IFC Center

14-16 Cornelia Street 323-327 Avenue of the Americas

The design for the proposed IFC Center was approved by LPC on November 16, 2015. The BSA variance review resulted in a programmatic change. Specifically, the two theaters on the upper floors of the Cornelia Street Building have been shifted to a rooftop addition to 327 Avenue of the Americas and four residential apartments will occupy the upper floors of the Cornelia Street Building. This change requires the following modifications to the project design:

IFC Center – 21 May 2018 – PROPOSED

14-16 Cornelia Street

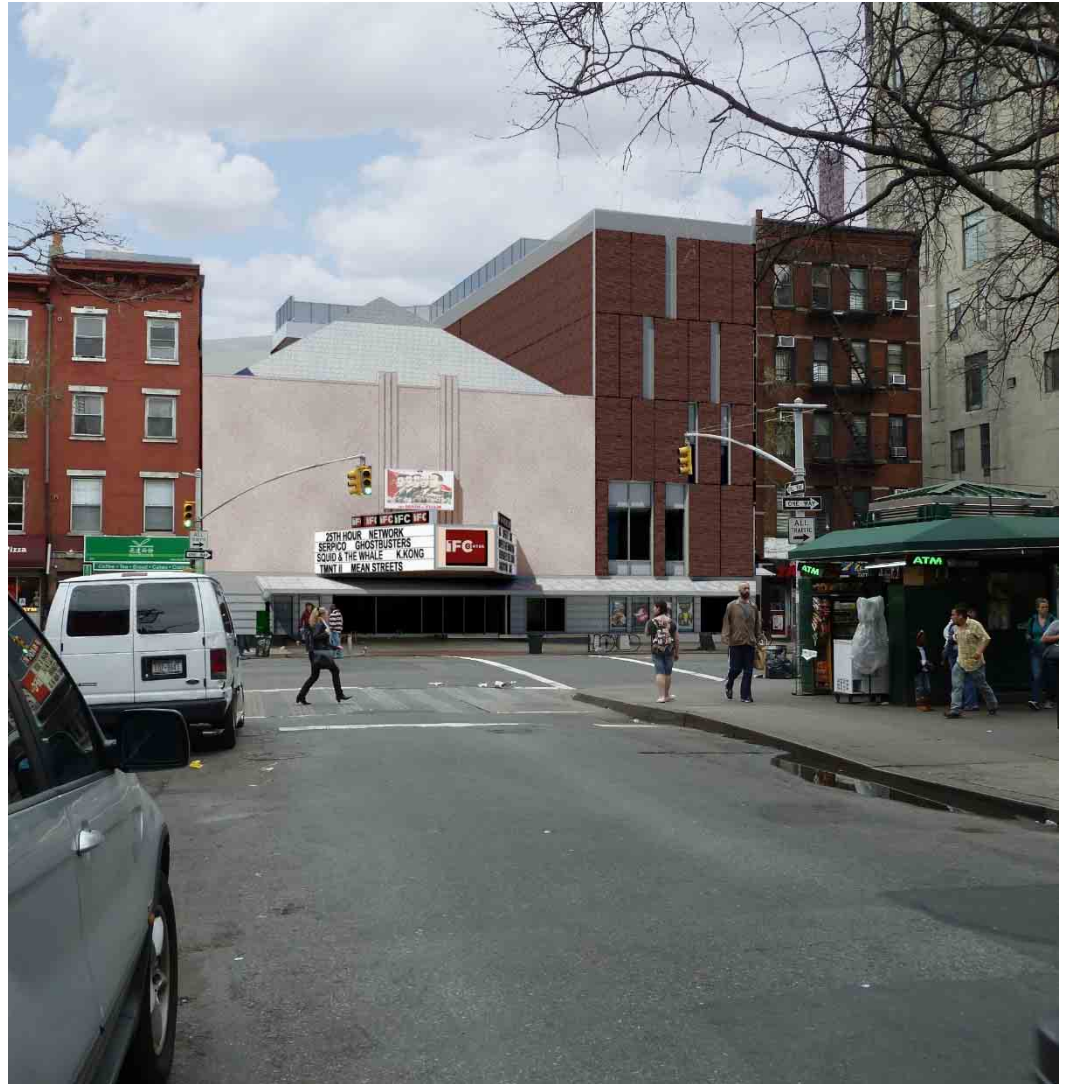
The original design included frosted fixed glass windows on the upper floors. These windows will now be operable and glazed with clear glass for the apartments. The ground floor waiting area remains, with an emergency exit. A residential entrance and lobby has been added at the north end of the façade.

323-327 Avenue of the Americas

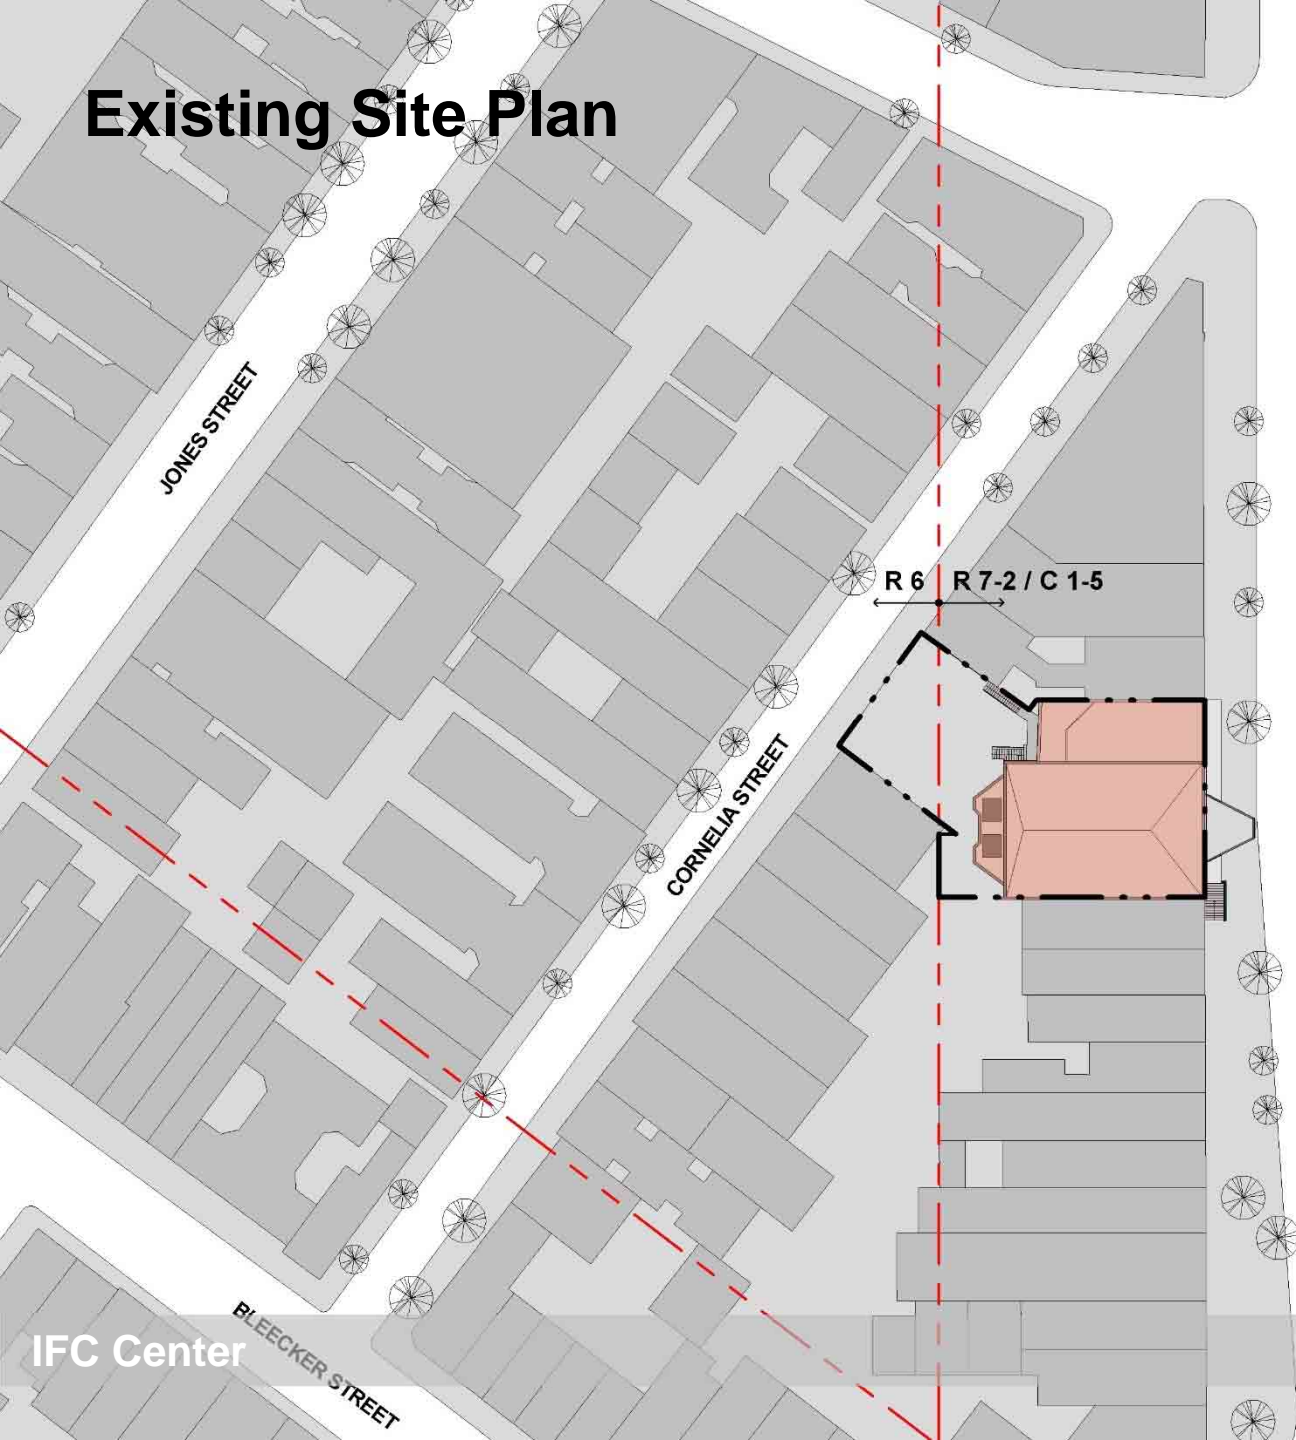
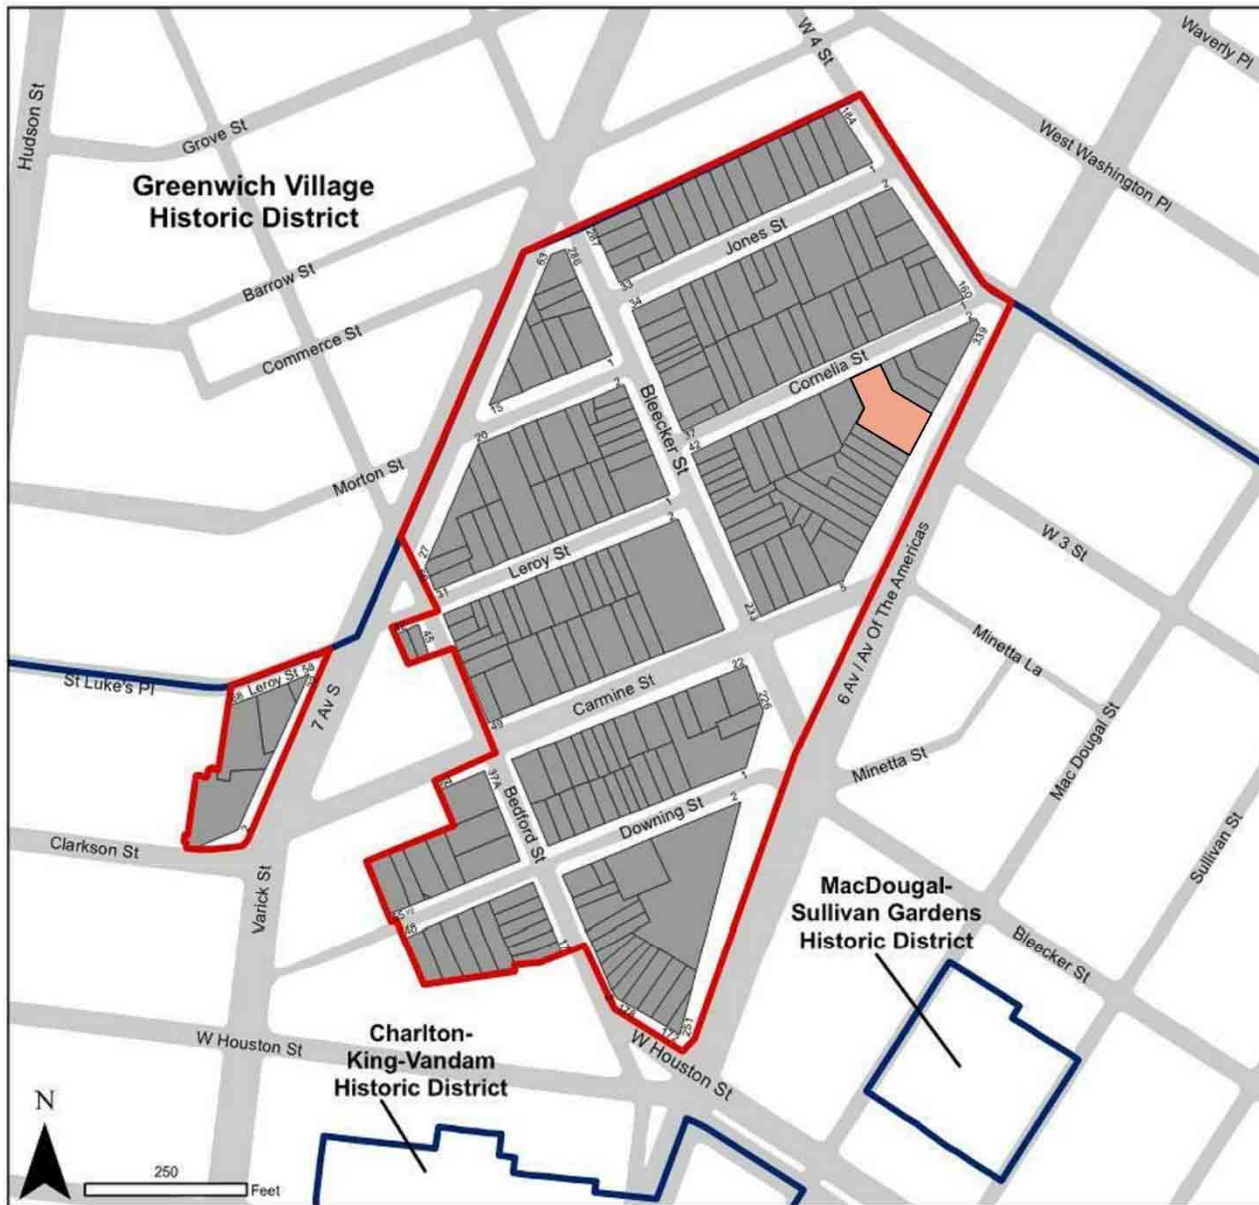
The two theaters that had been on upper floors of Cornelia Street are now located in a rooftop addition to 327 Avenue of the Americas that matches the height of 329 Avenue of the Americas. To create a new integrated façade design for the IFC Center that is more appropriate to the historic streetscape, the following modifications to the existing facades are proposed: Removal of the angled metal mesh screens and associated flood lighting currently on the facades of 323 and 327; Retaining the original marquee and narrow canopy below and relocating entrance and exit doors; Repair and repainting of the underlying existing stucco theater façade.

The new rooftop addition will be composed of brick and frosted glass elements that are related to the Cornelia Street façade.
